LETTER TRANSMITTING U S NAVY RESPONSES TO U S EPA REGION I, RHODE ISLAND  
DEPARTMENT OF ENVIRONMENTAL MANAGEMENT, U S FISH AND WILDLIFE AND  
NATIONAL OCEANIC AND ATMOSPHERIC ADMINISTRATION COMMENTS ON DRAFT  
SAMPLING AND ANALYSIS PLAN FOR CARR POINT WITH ATT

**DATE:** February 22, 2013  
**TO:** Distribution Listed Below  
**FROM:** Resolution Consultants  
**RE:** Response to Comments on Draft Sampling and Analysis Plan (SAP)  
Carr Point, NAVSTA Newport, Rhode Island

**NAVY RESPONSES TO  
U. S. ENVIRONMENTAL PROTECTION AGENCY (EPA)  
COMMENTS DATED DECEMBER 20, 2012  
ON THE DRAFT SAMPLING AND ANALYSIS PLAN,  
FORMER CARR POINT SHOOTING RANGE (MRP SITE 1, OU9) AND  
FORMER CARR POINT STORAGE AREA (IR SITE 22, OU10),  
NAVAL STATION (NAVSTA), NEWPORT, RHODE ISLAND  
(NOVEMBER 5, 2012)**

**FIGURE 6**  
**CONCEPTUAL REFERENCE SEDIMENT**  
**SAMPLE LOCATIONS**  
**FORMER CARR POINT SHOOTING RANGE**  
**AND STORAGE AREA SITES**  
**NAVSTA NEWPORT, RHODE ISLAND**

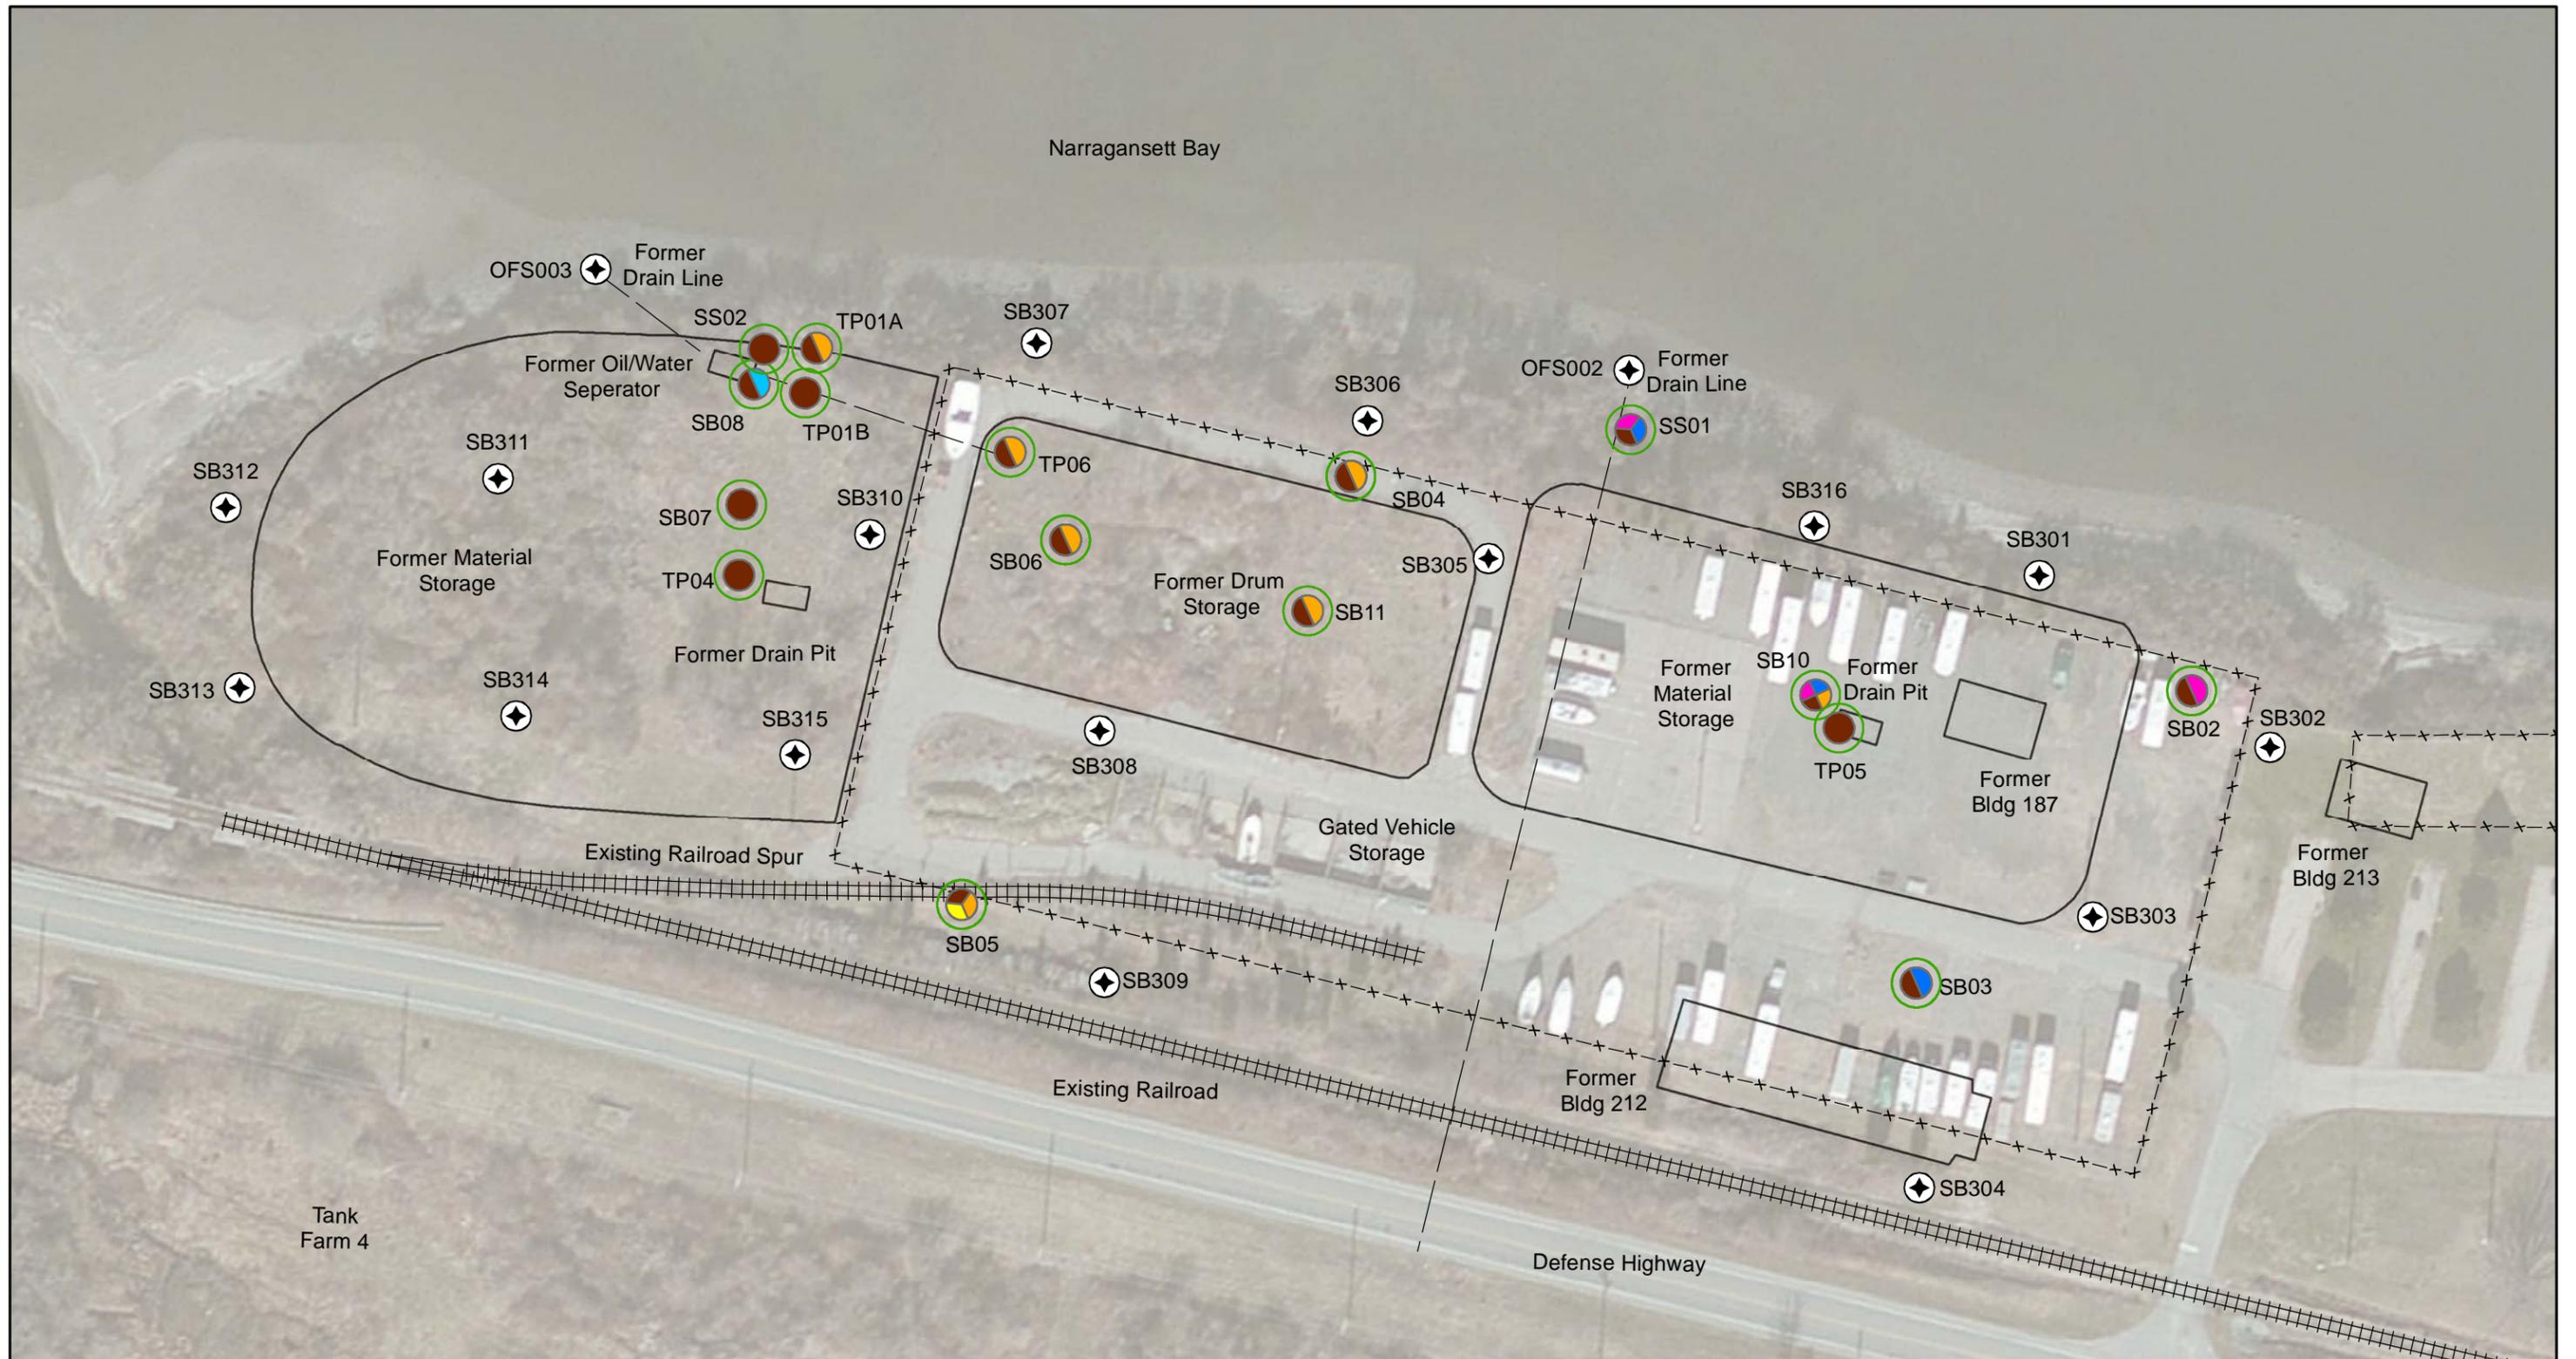
***Specific Comment 5: Worksheet 14-1 and 14-2, Page 152 and 159, Sediment Sampling, Background/Reference Locations:*** *With respect to the sediment background data collection effort, EPA recommends locating some of the background sediment samples in an area near the Carr Point site, but outside the likely extent of lead shot and other site impacts, in order to better match with site conditions such as grain size.*

***Specific Comment 14: SAP Worksheet #11-1: Figure 6:*** *I suggested moving some of the proposed reference/background sampling locations closer to the Carr Point area, outside the zone of influence, on our last conference call. It seems that potentially the intertidal/subtidal shoreline south of the site, well north of the Shipyard, may be an option, or the northwest shoreline of Dyer Island, on the same exposure profile as the site. Moving at least 1 of the proposed locations (3 samples) to one or both of these areas seems reasonable, dependent on local site condition evaluation prior to sampling. As discussed, grain size/TOC comparability to site conditions is an important issue and site history/current use patterns are also of concern. Qualitative or abbreviated grain size determination may aid in determination of reasonably comparable background locations.*

***Specific Comment 4:** I do not think that as many as 12 Reference locations are really necessary and the three furthest to the south are likely extraneous. Rather, take those three and place them in the shallow subtidal around the small island just to the north of the Shooting Range (Figure 6).*

**Response:** The SAP will be revised to reflect the collection of reference/background sediment samples in the vicinity of the Carr Point sites outside of impacted areas. Please refer to the attached figure (Figure 6) for possible background/reference sediment sampling locations.

**Response:** The SAP will be revised to reflect the collection of reference/background sediment samples in the vicinity of the Carr Point sites outside of the impacted areas. Qualitative assessment of grain size will be completed in the field to aid in the determination of appropriate reference/background sediment sampling locations. Also, TOC data will be collected from both the site and reference/background sediment samples for comparability. Please see attached figure (Figure 6) for possible background/reference sediment sampling locations.

**Response:** The Navy intends to collect up to 12 background/reference samples to further expand the available analytical background data set for sediments within Narragansett Bay. Of those 12 samples, 3 will be selected (with input from the stakeholders) to represent reference conditions for the sediment toxicity testing program and the macroinvertebrate community survey. Locations for the background/reference locations are still to be determined but a sub-set will be

located in relatively close proximity to the Carr Point sites themselves. Please refer to the attached figure (Figure 6) for possible locations for background/reference sediment sampling.

**Response:** As discussed on 1/16/2013, the background/reference sediment sampling locations have been revised. Please see the attached figure (Figure 6) for possible background/reference sediment sampling locations.

**FIGURE 10**  
**PROPOSED NEAR SHORE**  
**SEDIMENT SAMPLE LOCATIONS**  
**FORMER CARR POINT STORAGE AREA**  
**NAVSTA NEWPORT, RHODE ISLAND**

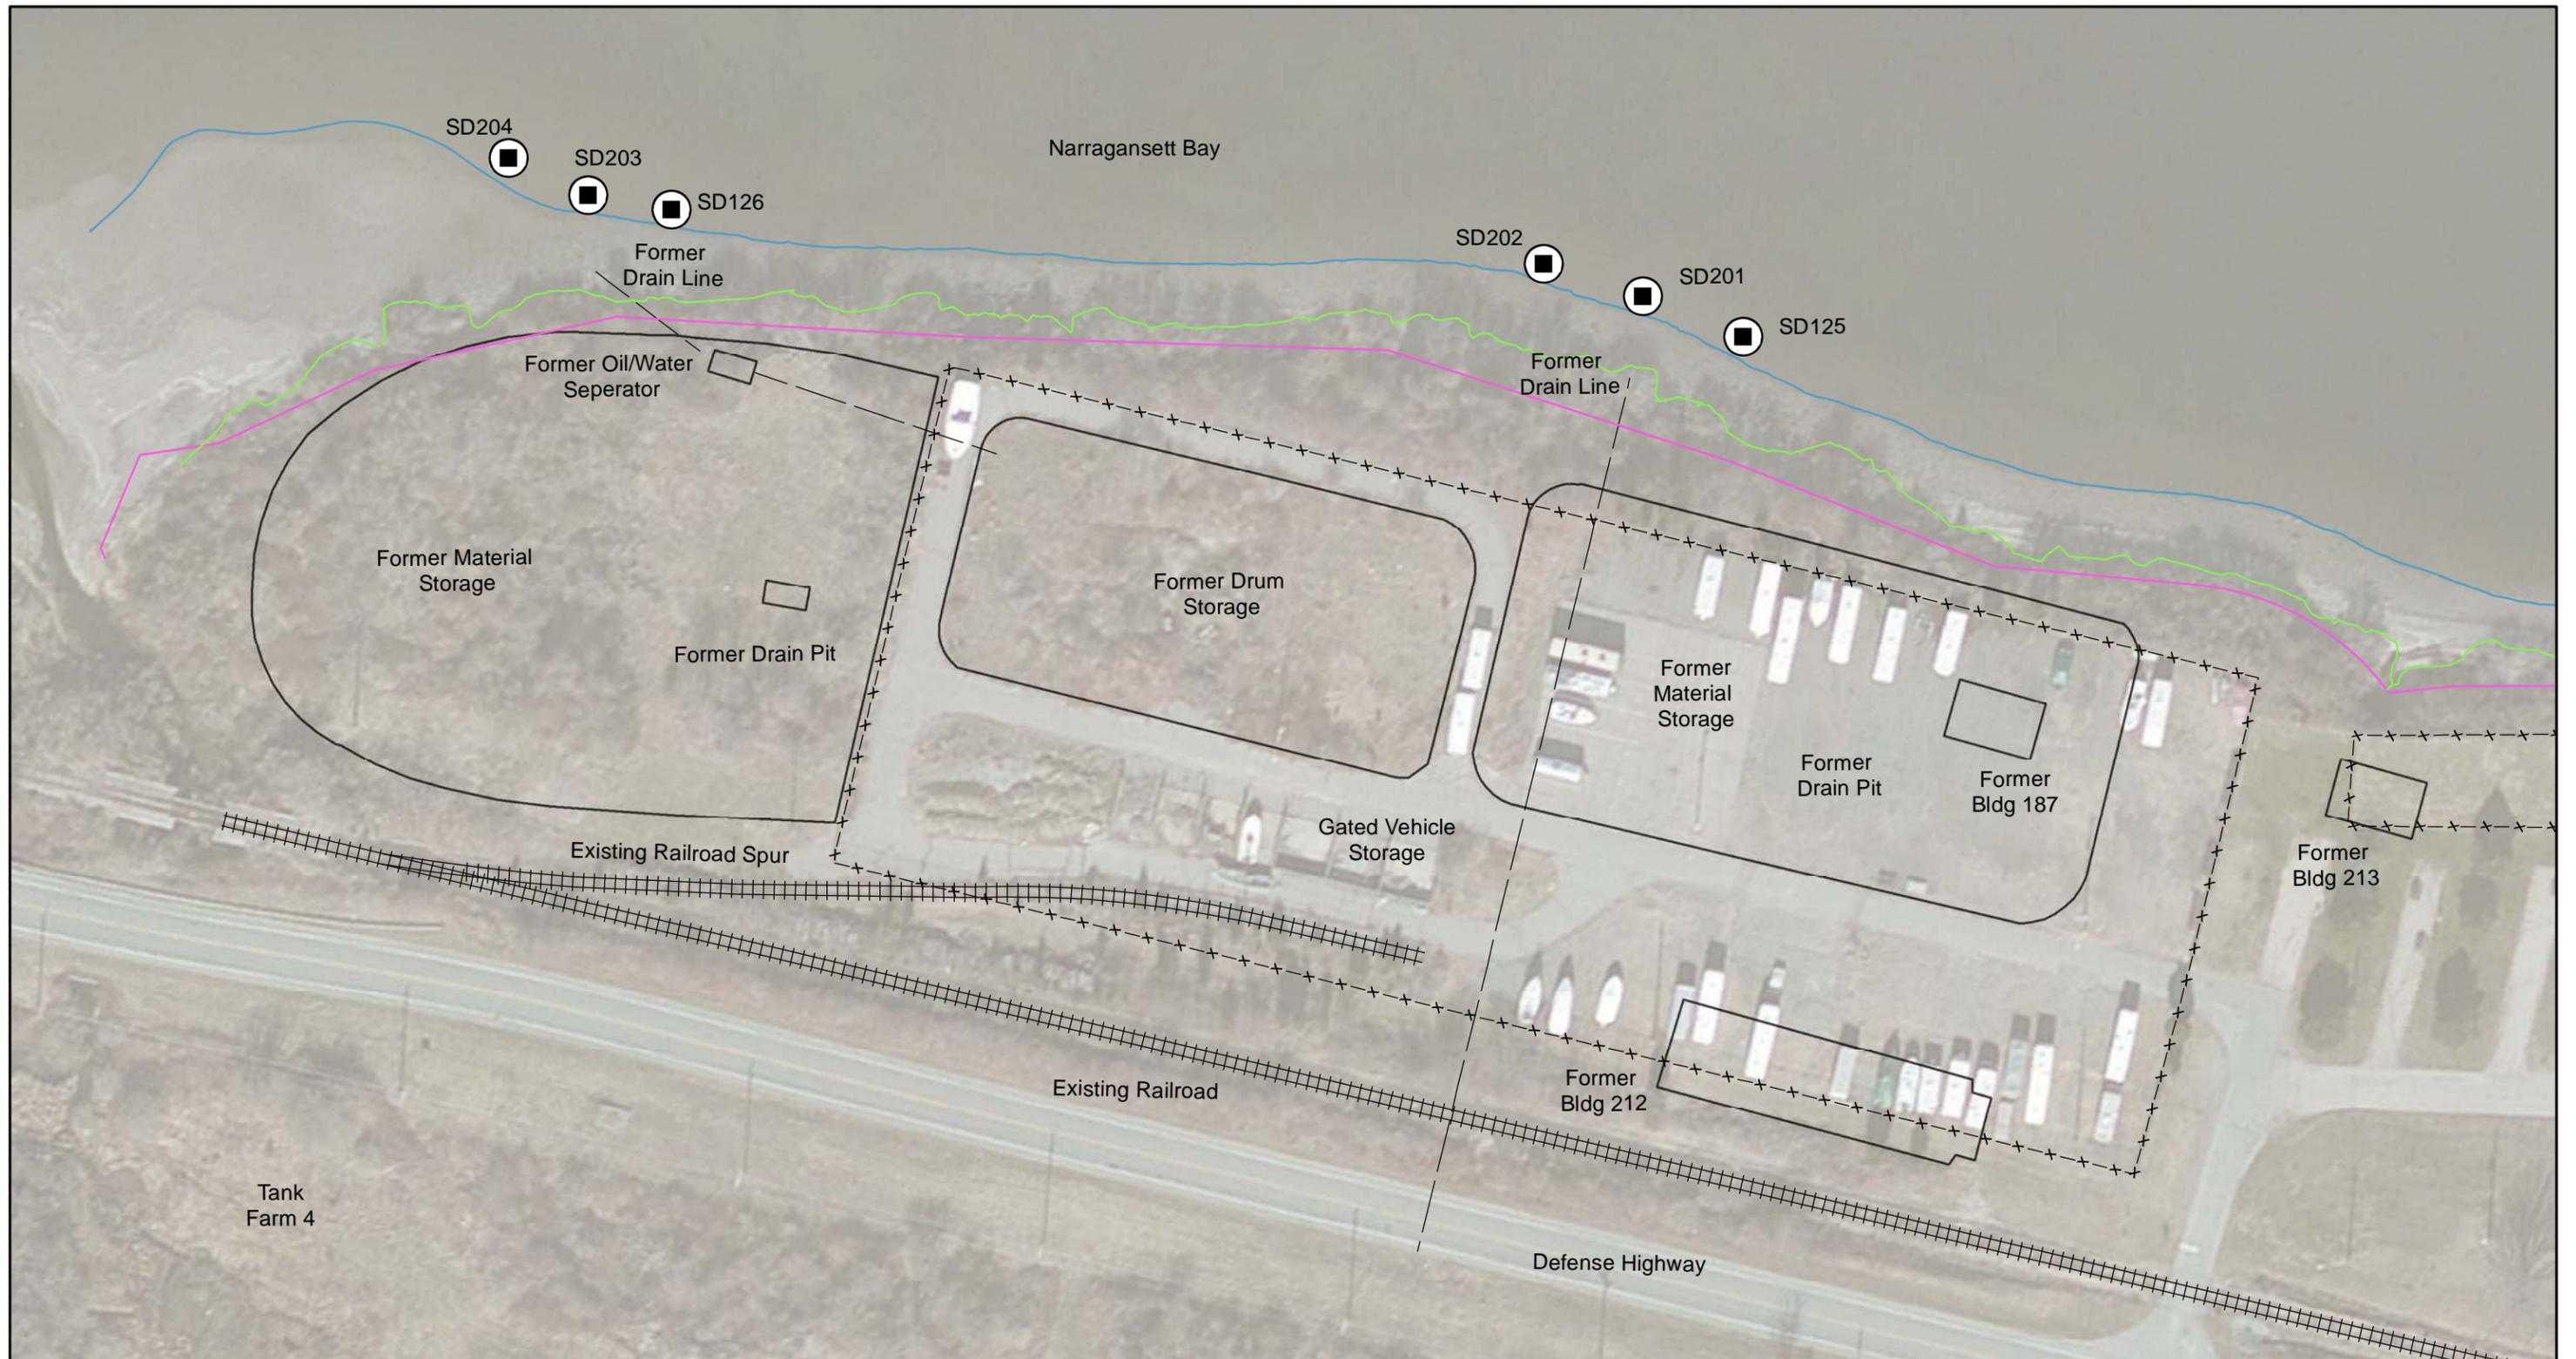
***Specific Comment 21: SAP Worksheet #14-2: Sediment Sampling:*** *As noted previously, 4 sediment locations (16 samples) to characterize the intertidal and subtidal area adjacent to the Former Storage Area is insufficient and deserves further discussion with the agencies.*

**Specific Comment 36: Figure 10 (IR Site 22):** *Please update this SAP to include additional sediment samples northeast of each of the former drain lines (i.e., northeast of SD201 and northeast of SD203) to adequately delineate the extent of contamination that may have discharged from the outfalls and may be affected by tidal action.*

**Response:** No sediment sampling has previously occurred at IR Site 22, so there is no basis to develop a tissue sampling program at IR Site 22. The proposed sediment sampling at IR Site 22 represents an initial effort to characterize the sediment conditions adjacent to the site. If warranted based on the chemical analysis of the sediments, additional sampling (e.g., shell fish tissue, toxicity testing) may be warranted in future phases. In addition, as discussed during the 1/16/13 meeting, the sediment sampling locations were revised for IR Site 22. Please see the attached figure (Figure 10) for the proposed sediment sampling locations.

**Response:** As discussed during our meeting on 1/16/2013, the sediment sample locations were modified. Please see the attached figure (Figure 10) for the proposed sediment sampling locations.
